**Proposal for Step-2 revision of Regulation No. 46**  
(Rear view mirrors)

Accordingly, the following changes need to be made in order for Japan to adopt R46:

(Fig.1)

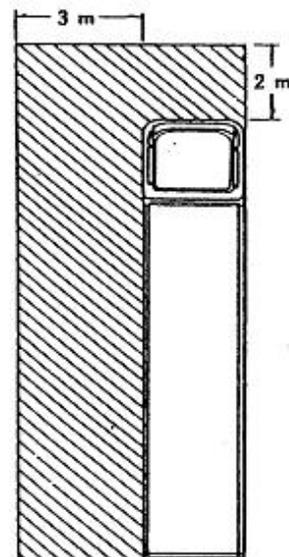
- (1) Visibility in the proximity of the vehicle (See Fig.1)
  - For vehicles of Category N2 not exceeding 7.5 tonnes and of Categories M1, M2, and N1, a pole, 30 cm in diameter and 1 m in height, which is placed in front of the vehicle or in the close proximity of the side of the front passenger's seat shall be partially visible through a mirror (including the surveillance mirror) or directly or by camera.
  - However, blind spots caused by A-pillars and other vehicle structures shall be excluded. (See InfGRSG-83-15.)
  - The surveillance mirror may be installed at a height of 2 m or less above the ground only if the impact test requirements are met.
  - In addition to the dynamic impact test required in the current regulation, the static impact test will be newly added, and one of the two tests may be chosen to satisfy its requirements.

Comparison of Blind Spots between Mirrors with 1,200 R and 600 R

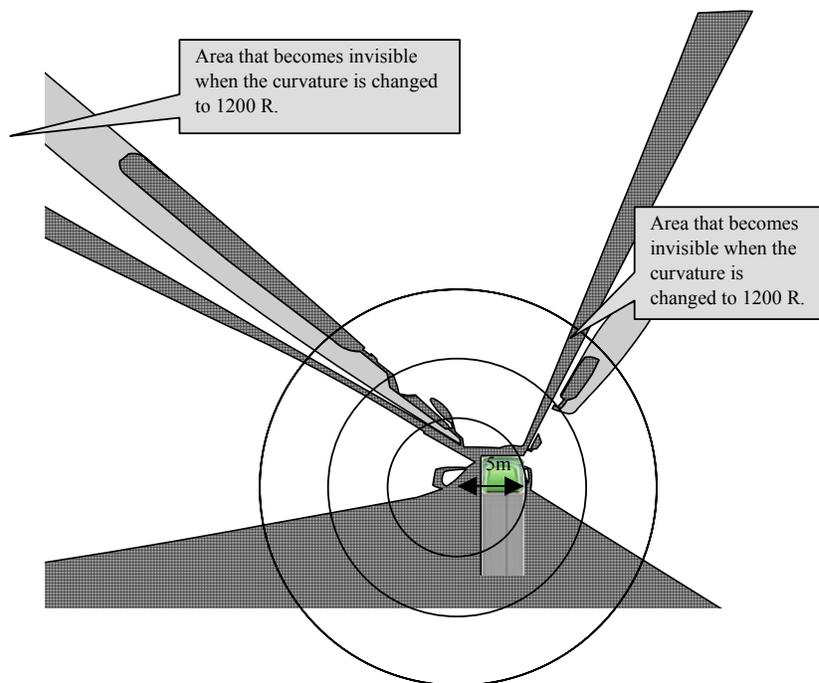
The degree of obstruction of direct visibility was compared between two mirrors, one with a curvature of 1,200 R and the other with 600 R, both having the same field of view.

Under this study of direct visibility, the invisible area was defined as a place where the blind spot on the ground and that on a horizontal plane at 1 m above the ground overlap. The figure below shows the blind spots getting wider when the mirror with 600 R is replaced with the one with 1,200 R. These areas play an important role when the vehicle turns on a narrow street, which means that an increase in the mirror curvature is associated with lowering of direct visibility.
